CM CLARIFICATION #004

PROJECT: CNE Tahlequah Casino

ADDENDUM # 001

Tahlequah Casino Addendum #01 summary

7 40X24 GRADE BM W/ CMU
1" = 1'-0"

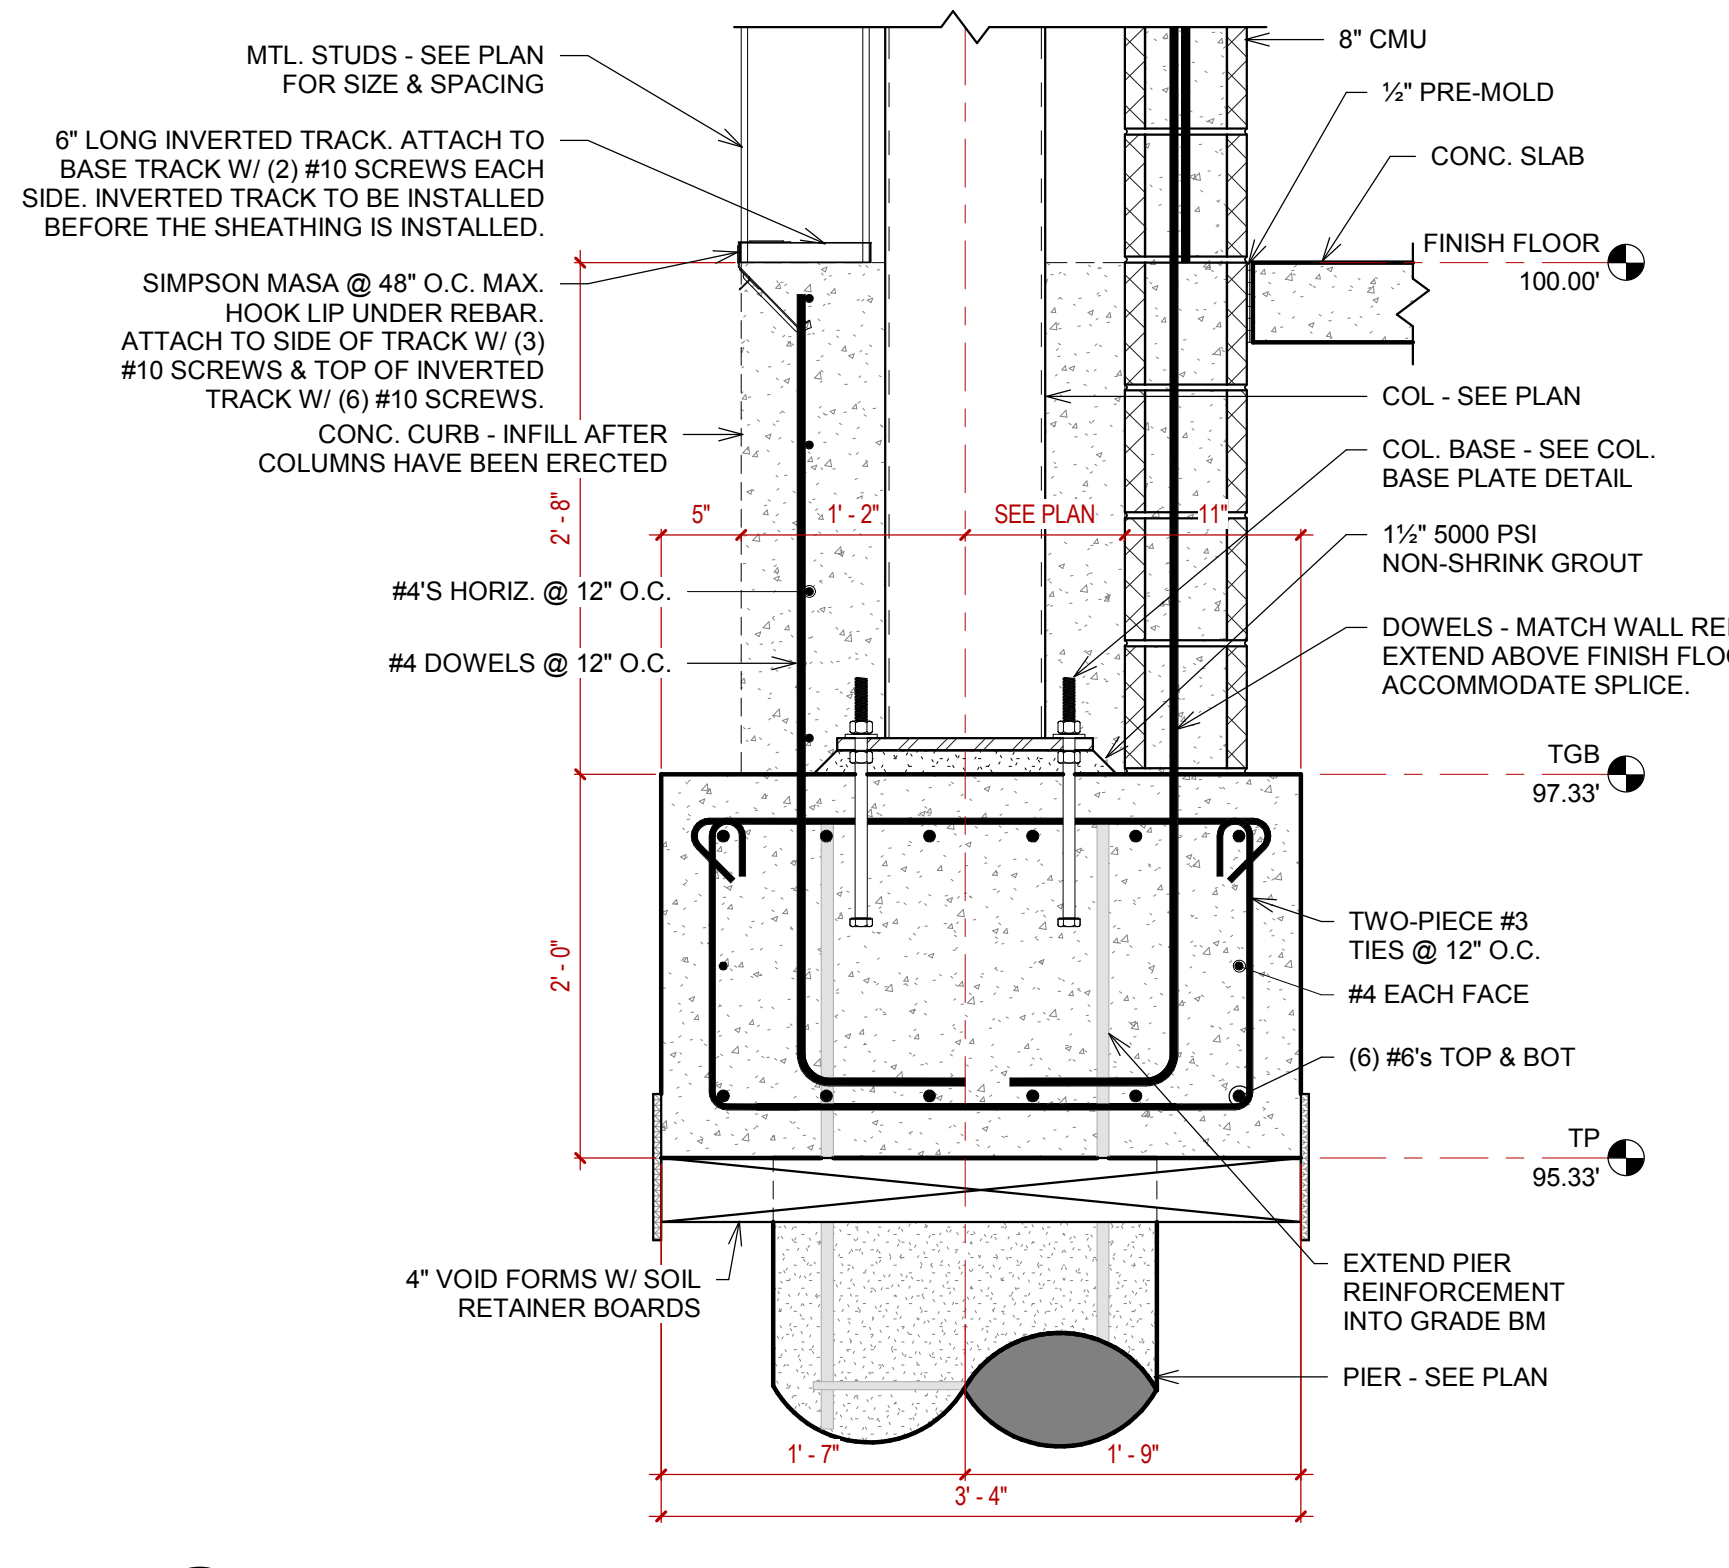
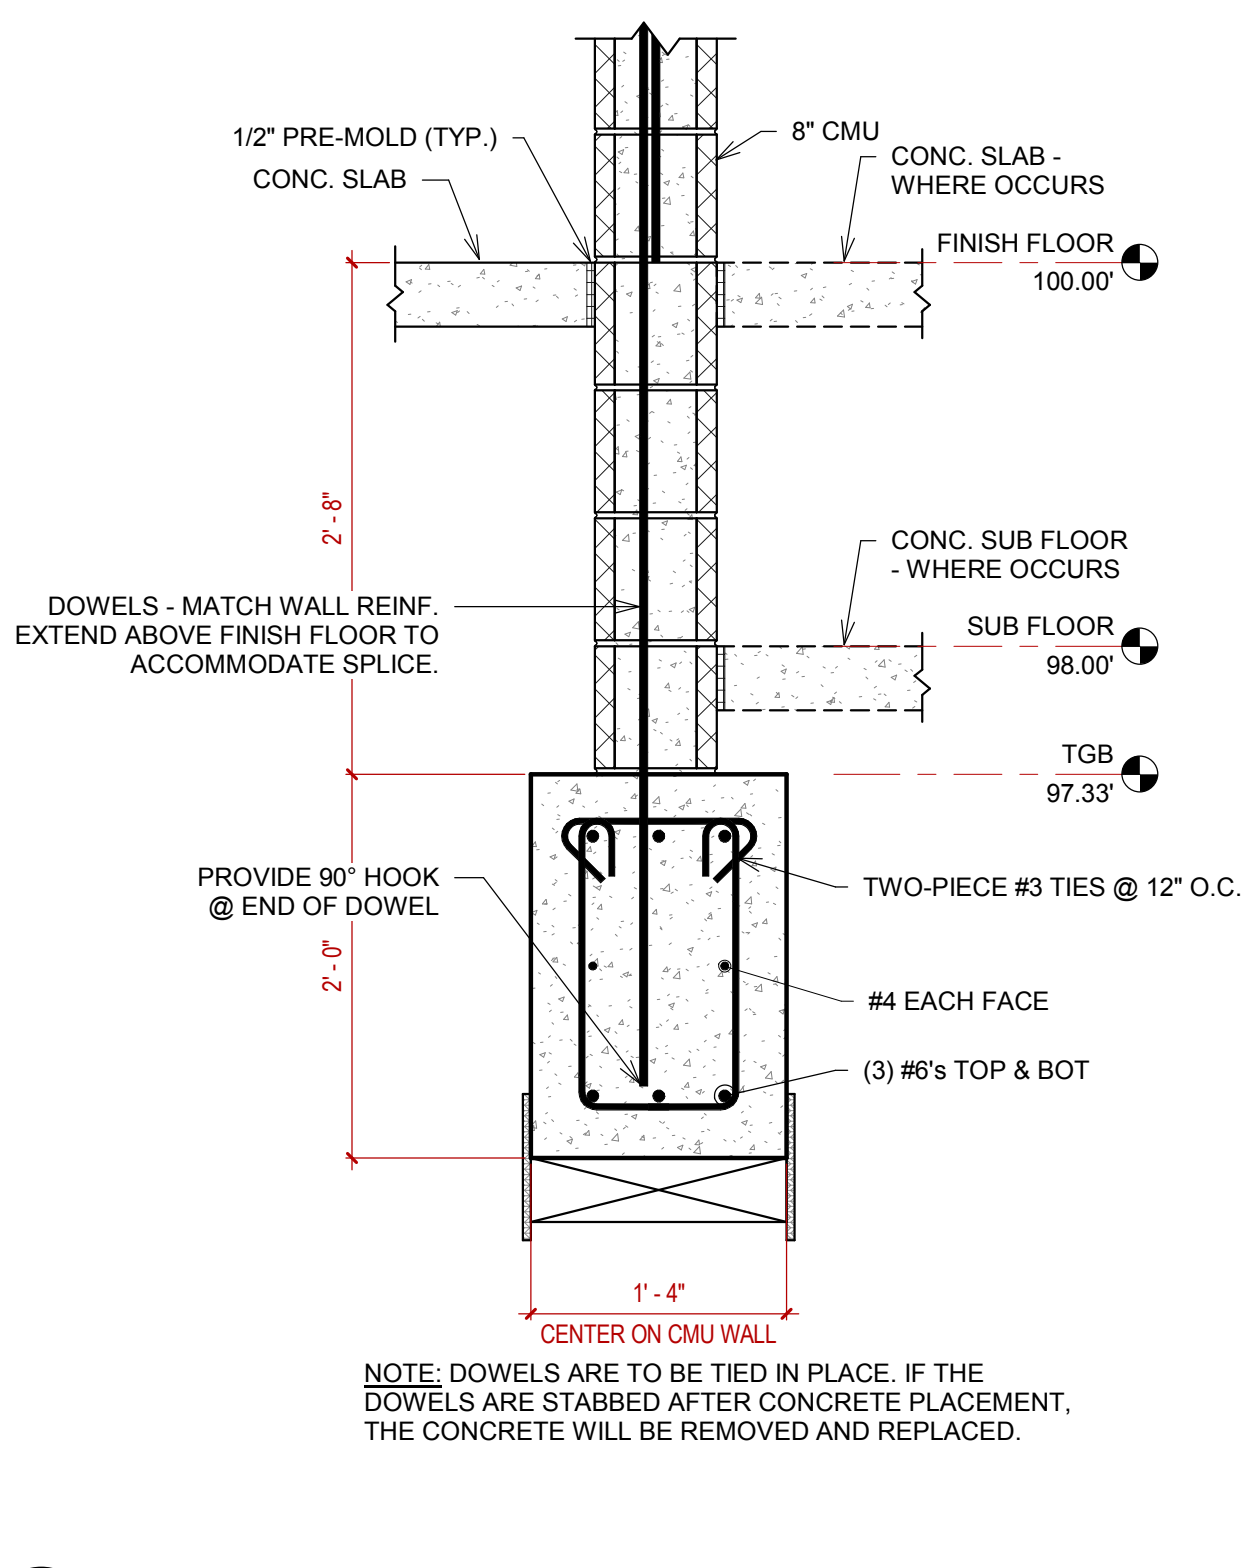
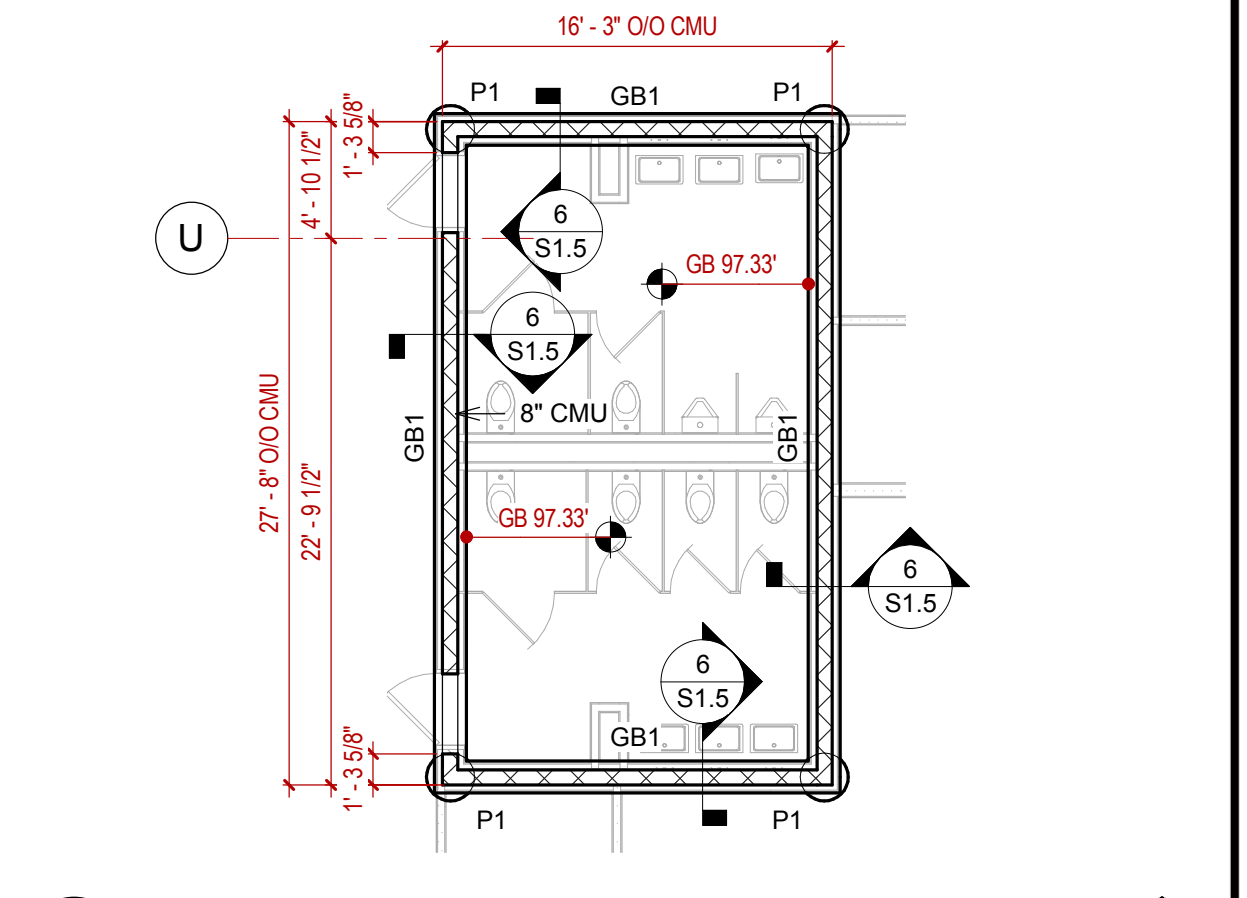
S1.5	Added sheet S1.5
S1.6	Added sheet S1.6
S1.7	Added sheet S1.7
S2.1	<ul style="list-style-type: none"> • Added enlarged stage pit plan and sections. • Added pit for dock levelers.
S3.1	<ul style="list-style-type: none"> • Revised roof deck to galvanize. • Revised column sizes.
S3.2	<ul style="list-style-type: none"> • Moved brace elevation from Y/BB-19 to U/BB-21 • Moved frame line 'DD' 1" east • Revised roof deck to galvanize. • Removed column @ U-19 & U-27.
